Re: Request for Council's Advice on SSD-74191717 – Badgerys Creek Industry Park

Attachment A – Detailed comments

Ref A: Road Setbacks to enable future Road Widening

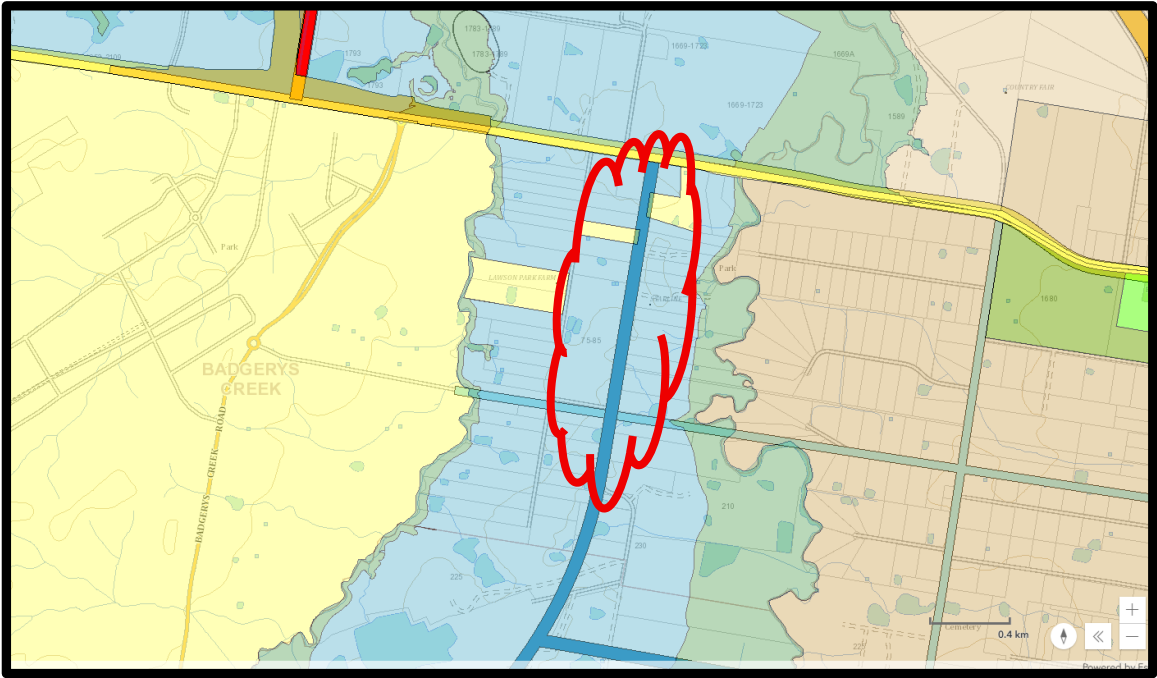
- a. The applicant has not proposed any road upgrades to improve the condition of Martin Road fronting their development, in that regard the following should apply as a “Condition of Consent” or “equivalent”:
 - i. Prior to the issue of a Construction Certificate, the applicant is to prepare a dilapidation report of Martin Road fronting the development by a suitably qualified individual, to inform Council on the condition of the road pavement associated with 85 Martin Rd (full frontage of the development including Stage 2 frontage).
 - ii. Prior to the issue of the Occupation Certificate, the applicant must carry out all road-based improvements identified in the post dilapidation report identifying the improvements required and agreed to by Council, including the full road width pavement and associated ancillary works (drainage etc).

- a. The applicant has not proposed any road upgrades to improve the condition of Lawson Road fronting their development, in that regard the following should apply as a “Condition of Consent” or “equivalent”:

- i. Prior to the issue of a Construction Certificate, the applicant is to prepare a plan detailing the full width reconstruction of Lawson Road fronting their development at 85 Martin Rd, Badgerys Creek for Council approval

- ii. Prior to the issue of the Occupation Certificate, applicant must carry out the full width reconstruction of Lawson Road fronting their development at 85 Martin Road, Badgerys Creek to Council’s satisfaction.

Figure 13 Typical Collector Road

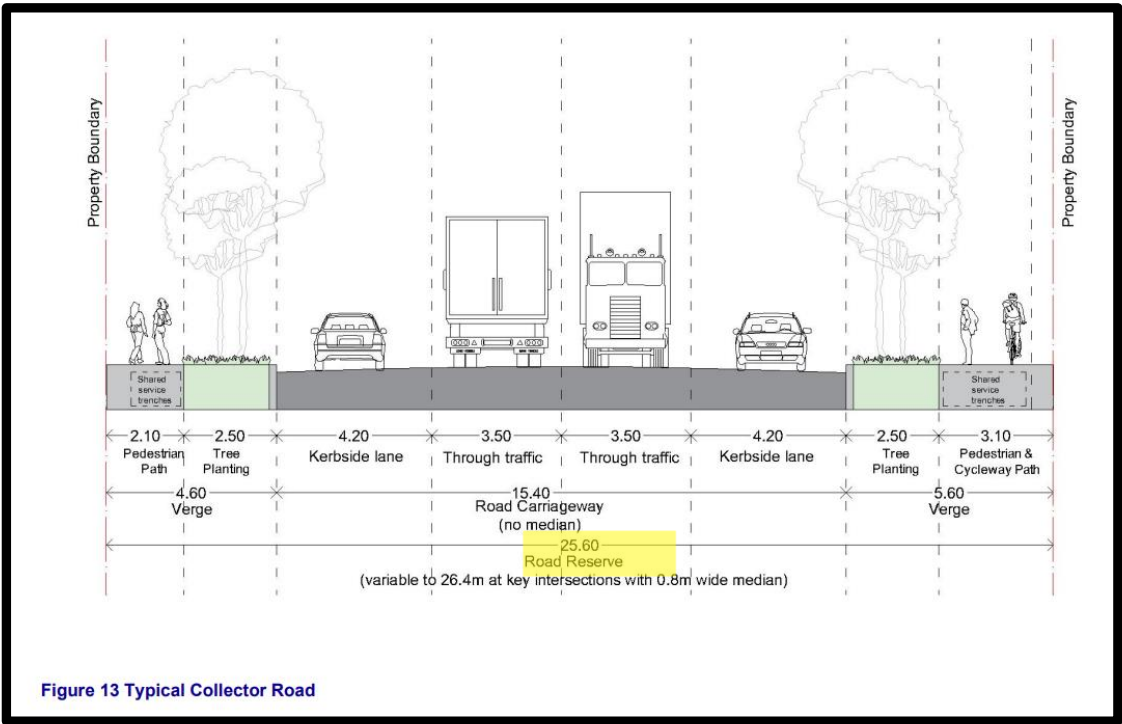
Comment: On this basis, Council does not support the proposal in the current form. It is requested that the proposal is amended to demonstrate how a WSAPP compliant road (including active transport and public transport) will be provided between the subject site and the broader regional network within the timeframe of any future SSDA determination. While there are likely multiple options for the proponent to demonstrate compliance, Council would recommend the following approach:

- (i) Confirm with TfNSW the timing of the availability of WSAPP compliant upgrades to Elizabeth Drive;
- (ii) Provide for the construction of the road reserve for the full frontage of the site in Lawson Road to the northern extent of Lawson Road identified under the Liverpool s7.12 Aerotropolis Contributions Plan; and
- (iii) Liaise with relevant private Landowners provide an interim connection from Lawson Road to Elizabeth Drive for that portion of Lawson Road not identified under the Liverpool s7.12 Aerotropolis Contributions Plan; and
- (iv) Liaise with TfNSW in relation to the provision of a suitably designed Elizabeth Drive/Lawson Road intersection as an interim arrangement prior to the provision of the Eastern Ring Road and associated access intersections.

Figure 8: Transport Network

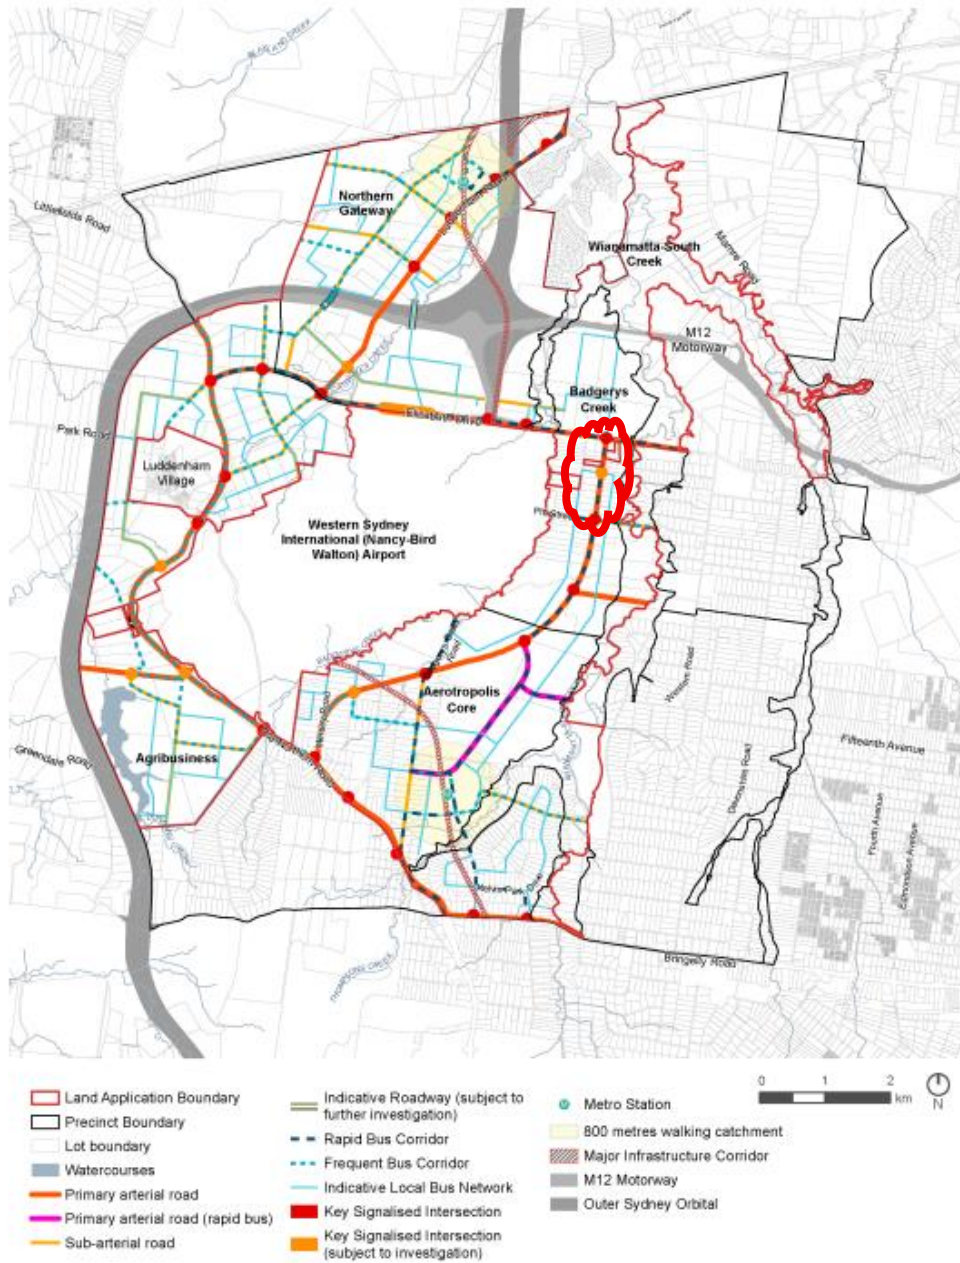
The submitted EIS does not demonstrate how the proposal will satisfy the requirements of the WSAPP in relation to road connection to the broader network. The proposal does not demonstrate compliance with Chapter 3 of the WSAPP in this regard. The development must demonstrate the provision of a WSAPP compliant road reserve on site with the capacity to provide all regional vehicular, pedestrian and active transport connections on site and the availability of a WSAPP compliant road reserve connected to the existing regional system.

In this regard, the proposal must demonstrate that a WSAPP compliant connection will be available;

- linking the site to an upgraded Elizabeth Drive via Lawson Road as an interim solution and
- providing access to the Eastern Ring Road from the Lawson Road access to the site via a TfNSW approved intersection/intersections likely via Lawson Road and Pitt Street.
